~~of~~ Alaska
Department of Fish and Game
Nomination for Waters
Important to Anadromous Species

86-318

Name of Waterway St James

AWC# of Waterway 115-10-10450-2005

115-10
2005
10460
10450
10130
CO
CH
(JUNEAU C-5)

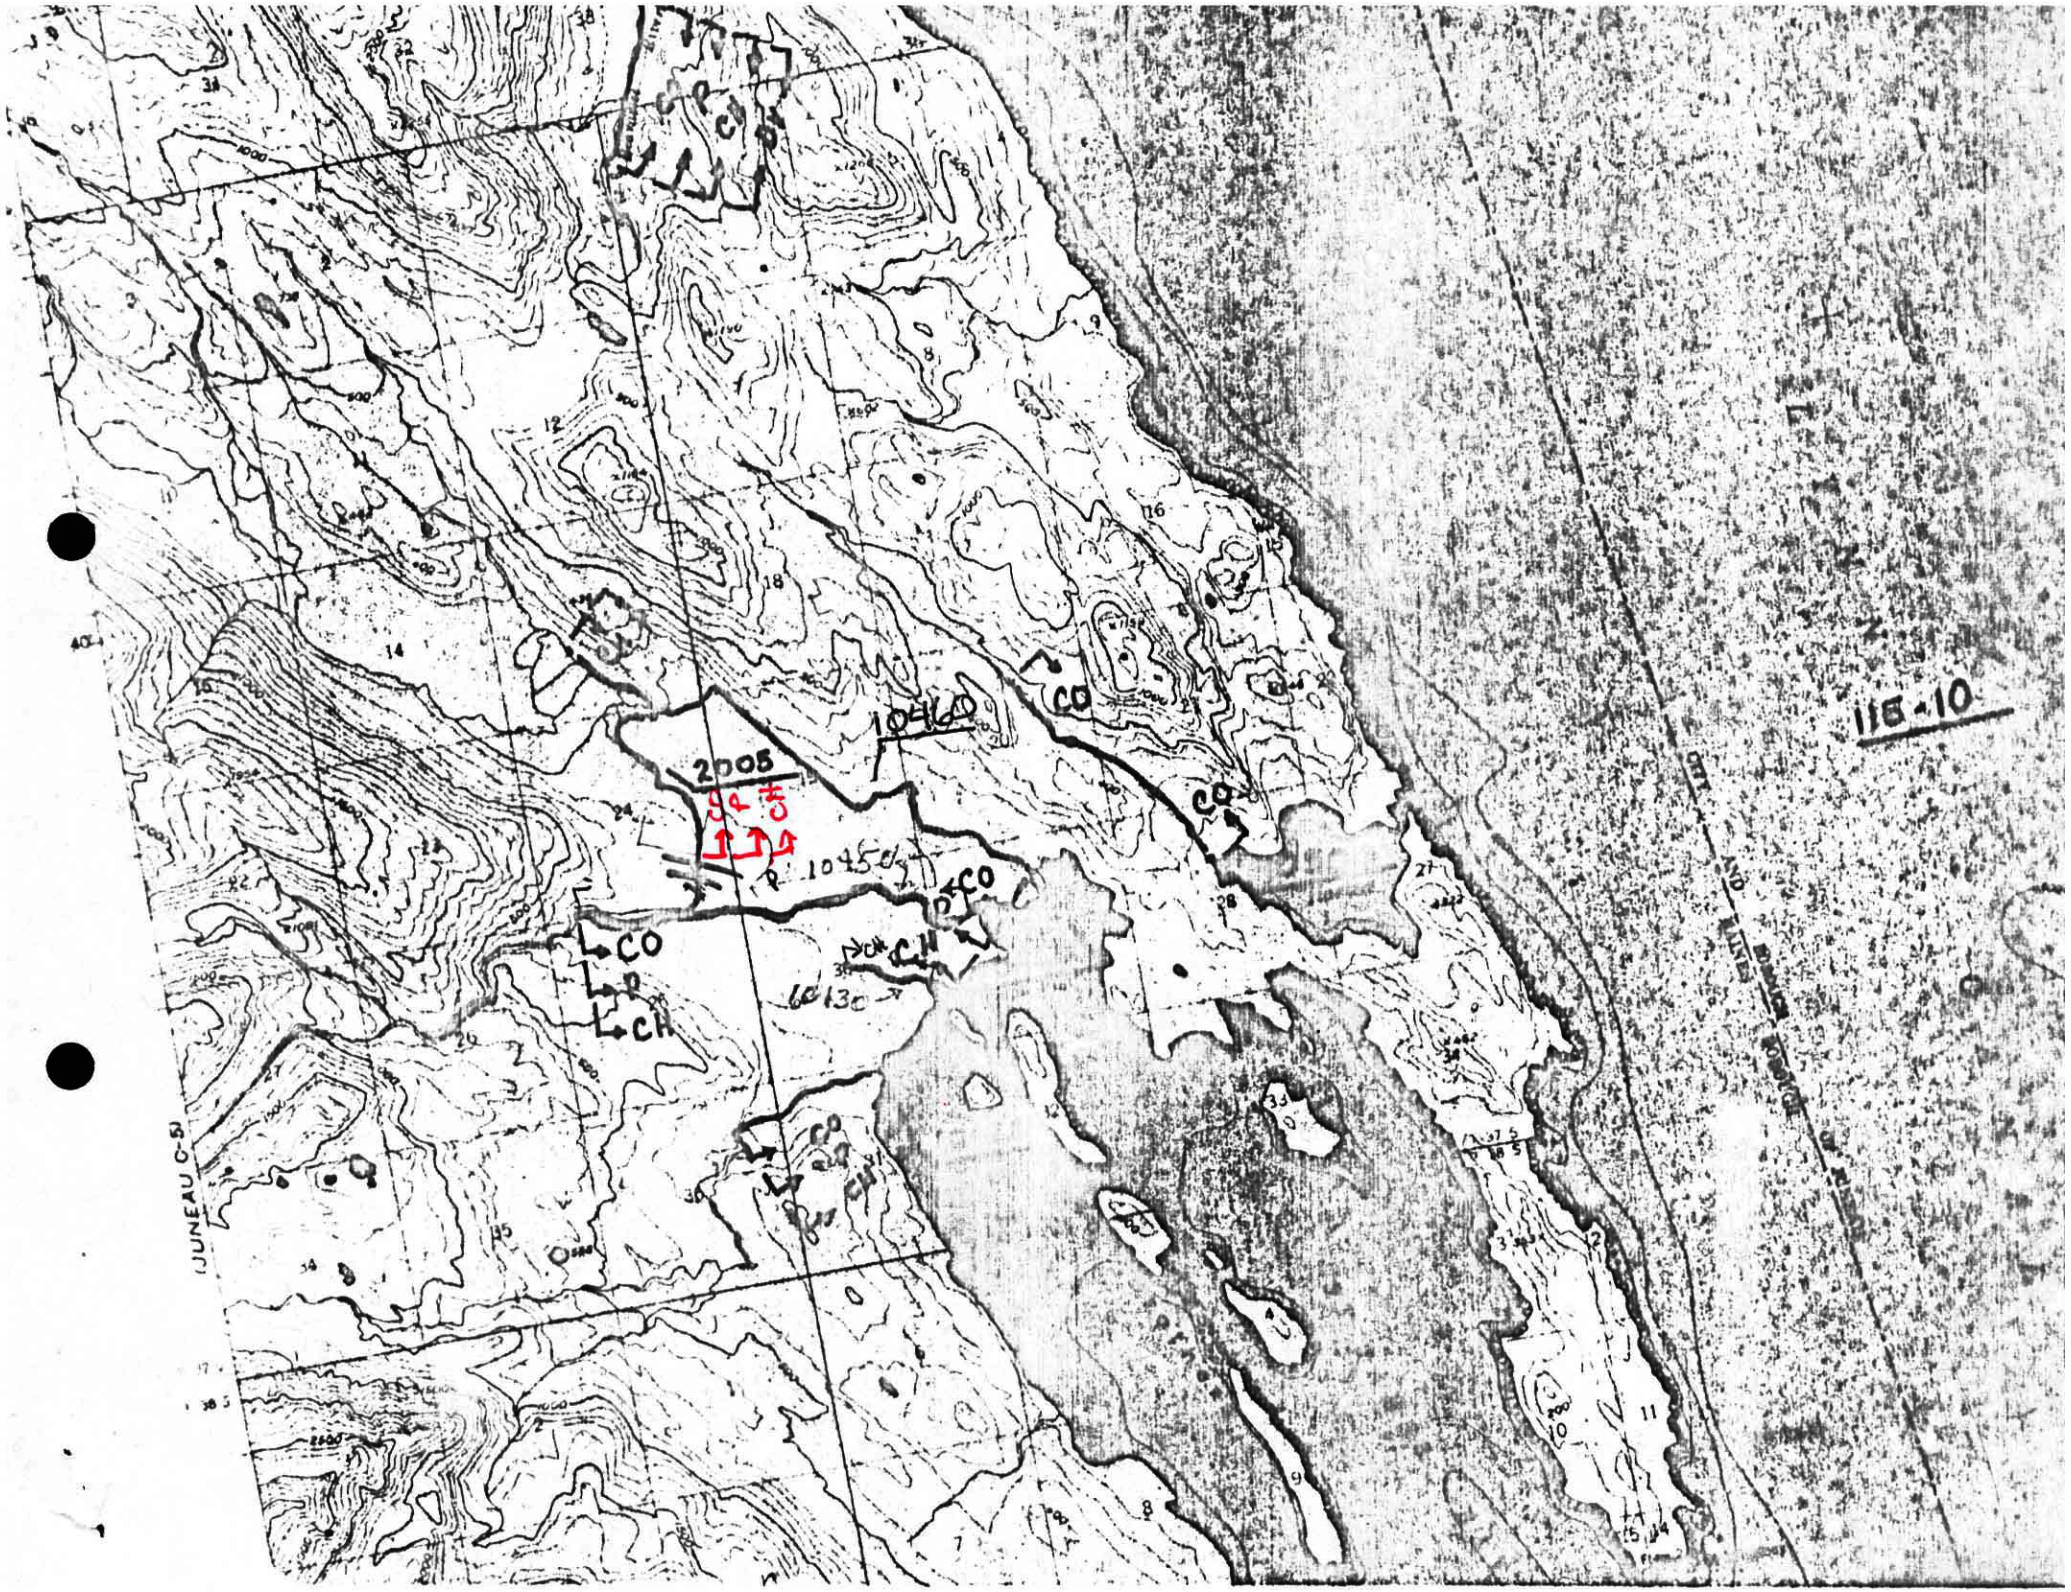
Delete upper portion as shown

Drainage for St James Creek is incorrect on map. 10460-2005 is actually 2 separate creeks with 2 separate outlets upper drainage of 2005 actually drains through red line drawn on map. Creek would most likely be labeled 115-10-10450
